U. S. NUCLEAR REGULATORY COMMISSION  
REGION I

Docket/Report: 50-317/86-09  
50-318/86-09

Facility: Calvert Cliffs Nuclear Power Plant, Units 1 and 2

Summary: May 1 - June 30, 1986: Inspection Report 50-317/86-09, 50-318/86-09.

21 SGFP speed Control

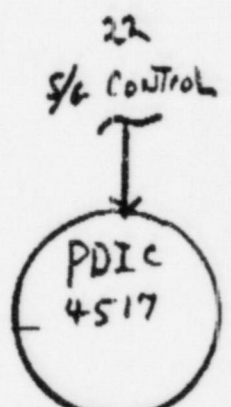
Reference: Attachment 1. The recorders previously connected to PDIC and PDT 4516 and 4517 were reviewed for response at the time of the event. At the time, PDIC-4517 was in automatic and 4516 was in manual, (a normal configuration during operation). PDIC-4517 a reverse acting controller showed a response in the full output direction initially, followed by a one quarter scale oscillation near the upper range of the scale. PY-4516 basically traced an exact image of PDIC-4517's output (as expected). Recorder traces for PDT-4516 and 4517 show an initial spike in the increasing signal direction followed by a full scale oscillation for PDT-4517 and three quarter scale oscillation for PDT-4516. The licensee concluded that the trace indicated a spurious signal originating at PDIC-4517 in the increasing direction was passed through PY-4516 which in turn caused an increase in the Lovejoy speed control signal to the feed pumps. As a result, feed regulating valve differential pressure increased causing an increase in PDT-4516 and 4517 output (normally this would have resulted in a decrease in the output signal). Based on this response it was believed that PDIC-4517 failed in the high direction eventually causing the feed pumps to over speed.

Subsequently, modifications were made on 2R01A to separate the bus supplying power to the two steam generator feed system control loops. These modifications consisted of lifting the power leads at 2R01A and installing two new power supplies.
